**Daimler Trucks
North America LLC****Recall Campaign**February 2010
FL566A
NHTSA #09V-452**Subject: Sterling 360 Air Intake Duct Cushions****Models Affected: Specific Sterling 360 vehicles manufactured
January 25, 2006, through November 30, 2008.****General Information**

Subject: Sterling 360 Air Intake Duct Cushions

Fig. 1, Air Intake Duct Removal

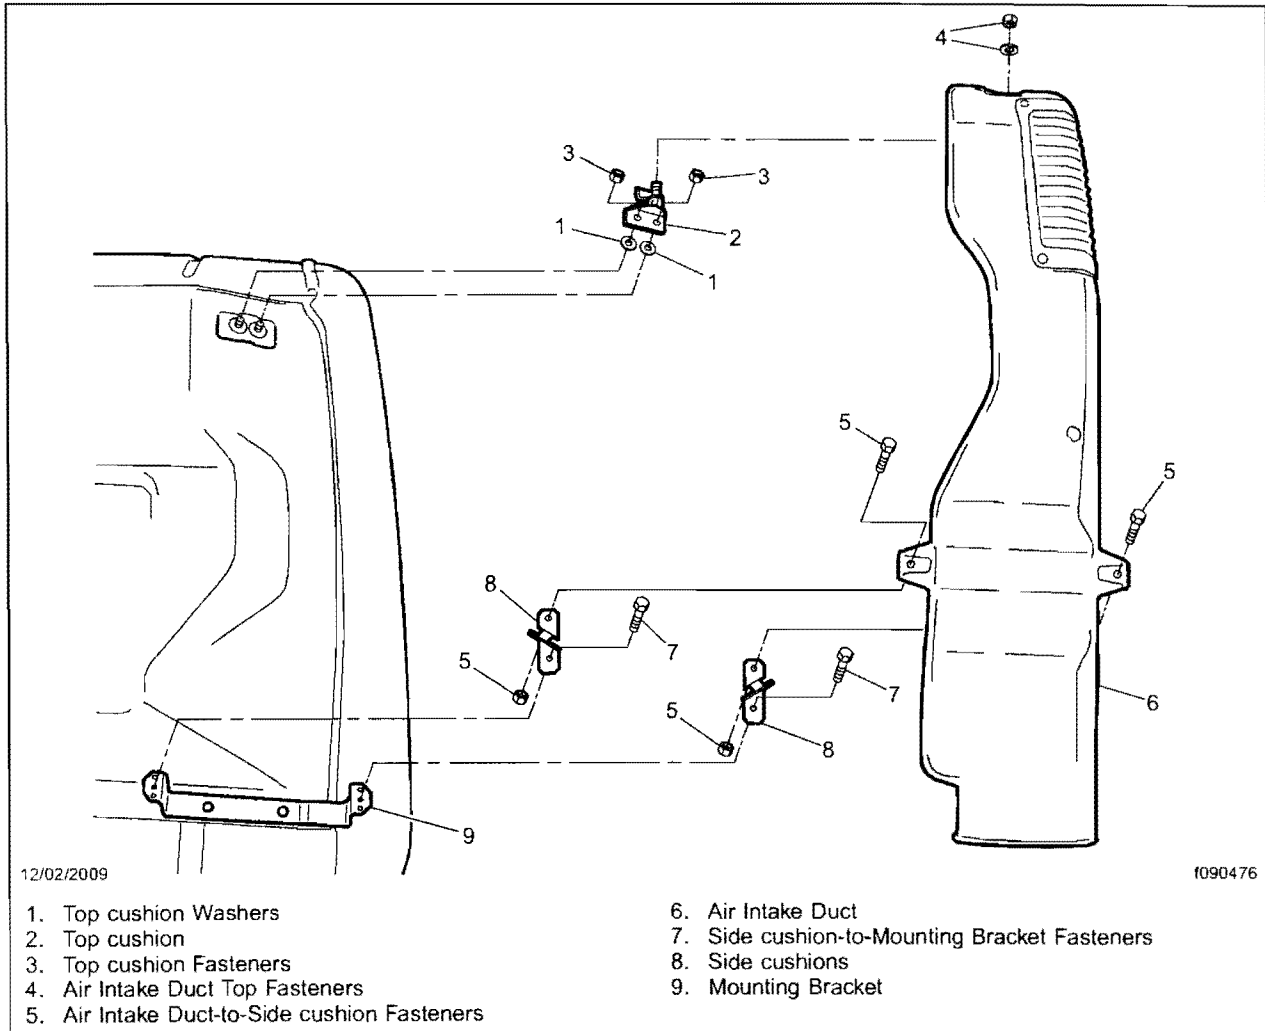
The weather resistance properties of certain engine air intake duct rubber cushions is insufficient. During normal vehicle operation, the cushions may deteriorate and crack, causing abnormal noise. In the worst case, all of the rubber cushions could crack and break, allowing the air intake duct to separate from the vehicle, resulting in a possible road hazard or vehicle crash.

The rubber engine air intake duct cushions will be replaced with more robust cushions.

4. Tilt the cab.
5. Remove the air intake duct top mounting fasteners. See Fig. 1.
6. Remove the side cushion-to-mounting bracket fasteners and remove the air intake duct. Do not remove the air intake duct mounting bracket on the back of the cab.
7. Remove and discard the top cushion.
8. Remove and discard the side cushions from the air intake duct.
9. Install a new top cushion on the back of the cab.
10. Install two new side cushions on the air intake duct.
11. Mount the air intake duct on the mounting bracket. Install and tighten the side cushion-to-mounting bracket fasteners.
